CITY OF ALBUQUERQUE

July 22, 2019

RE: **BEK Distribution Facility – 601 Gallatin Pl. NW**
G&D Plan and Drainage Report Engineers Stamp Date: 7/19/2019,
Hydrology File: FJ10D002G1

C201

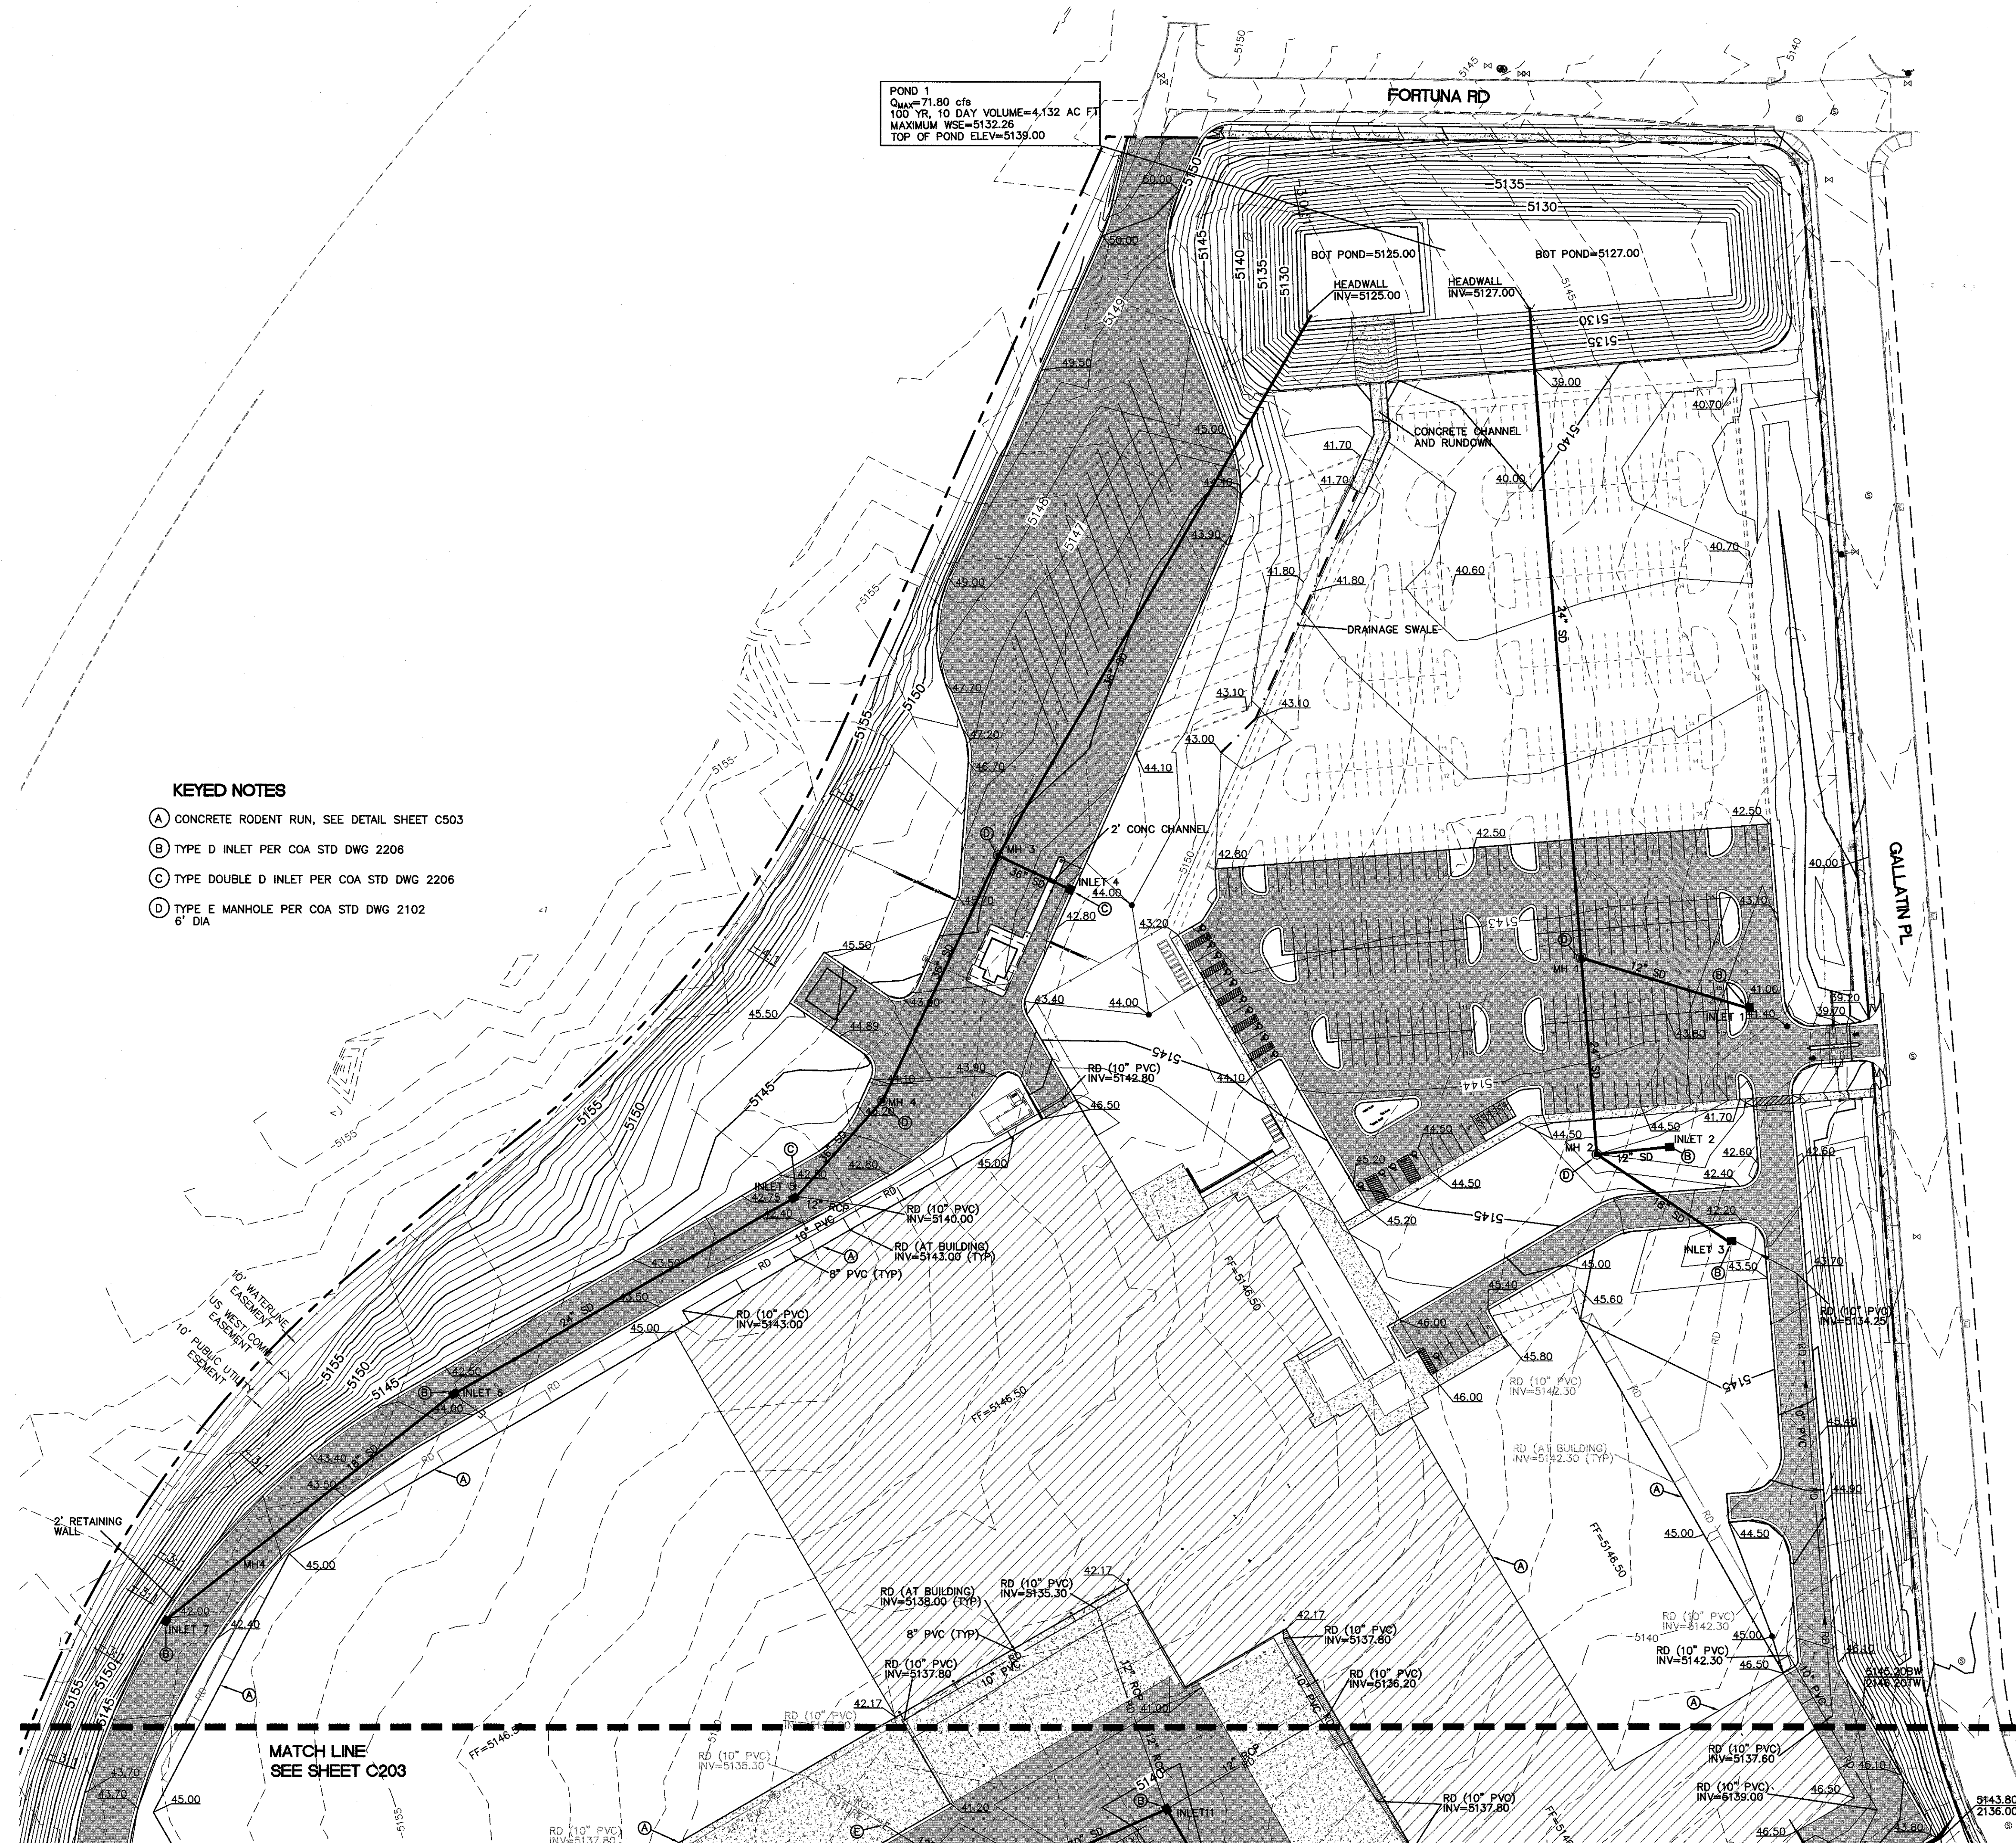
12. Please add the Book and Page (B 2019C P 0040) of the plat to note 1 on sheet C201.
13. The south pond must have a non-erosive spillway. Please add a build note and a detail on the G&D Plan. Please check the weir coefficient, 1.6 is for metric units, 2.7 is SI for broad crest, and 3.3 SI for sharp crest.

SECTION A-A

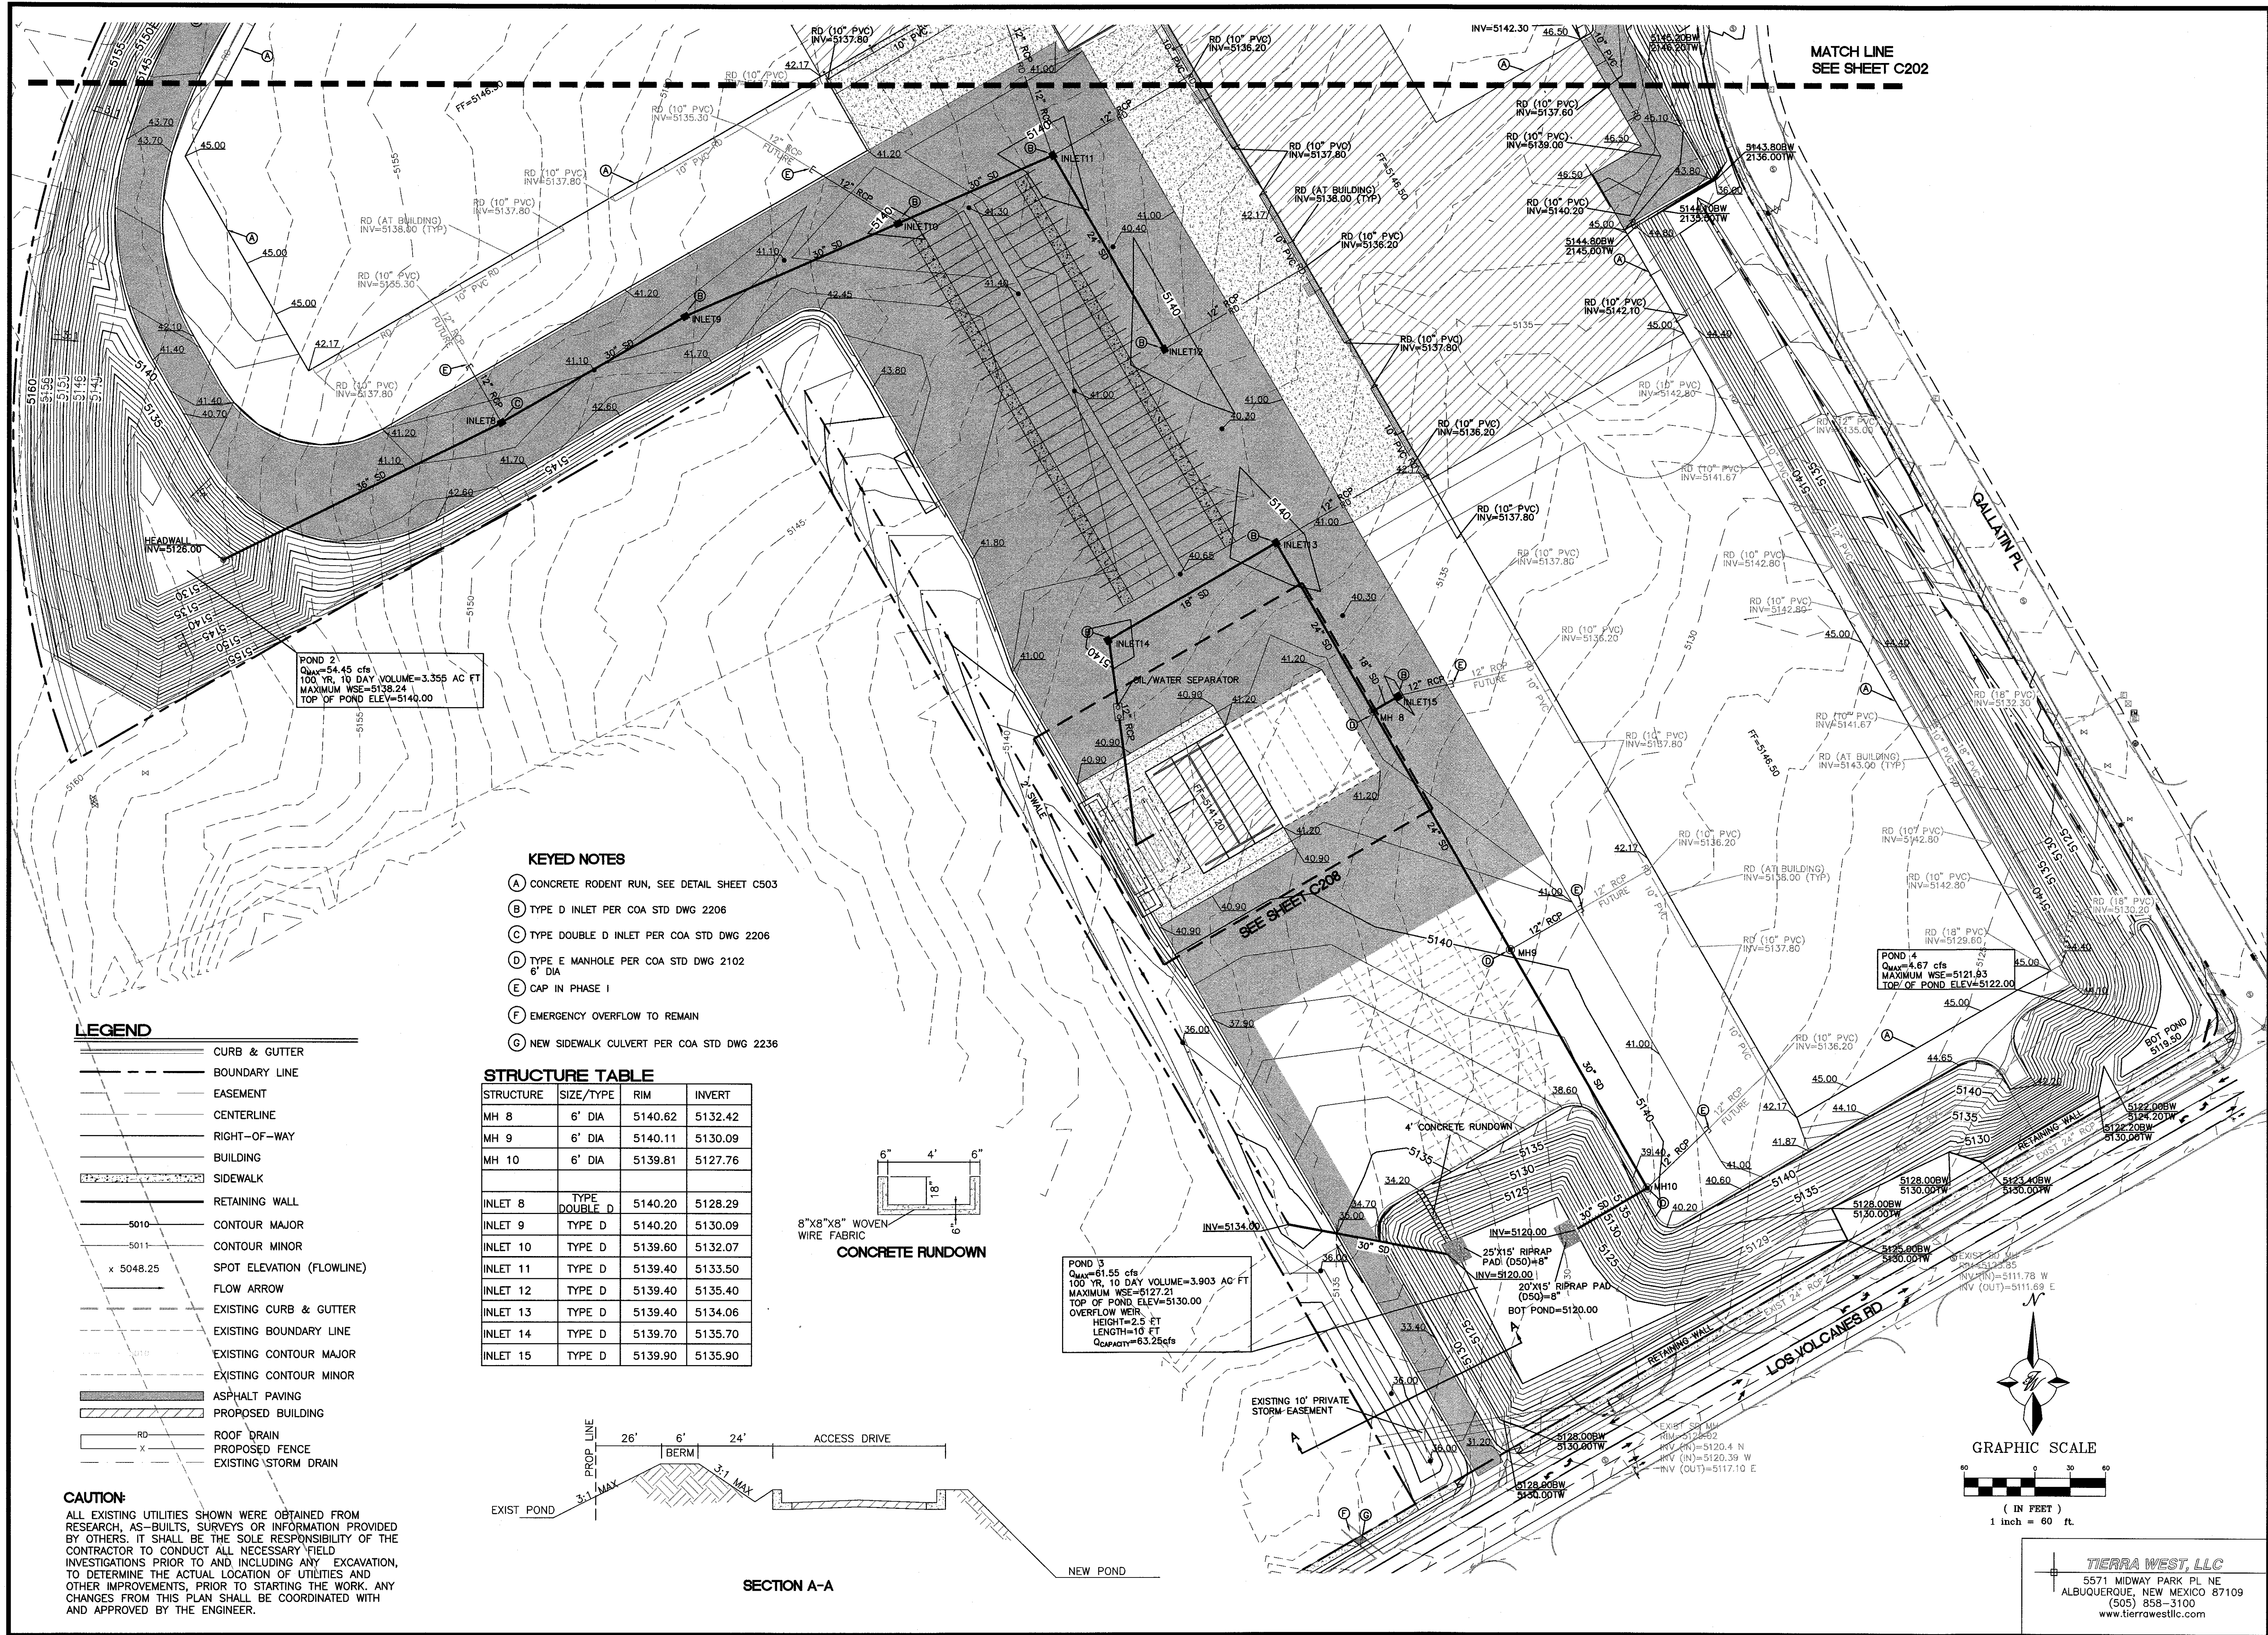
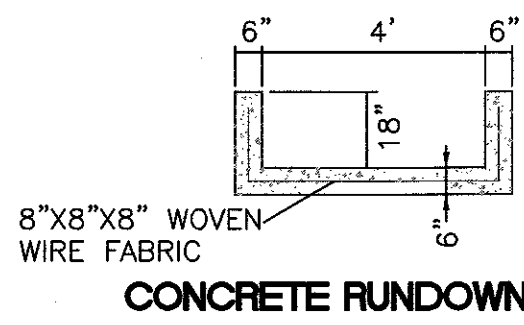
- c. The existing Dam may encroach on this site. A minimum 6' wide top of dam must be maintained. Section A-A on sheet C203 may need to be updated with the results of the revised survey and hopefully get the dam off of the BEK property and back onto the Coca-Cola property.
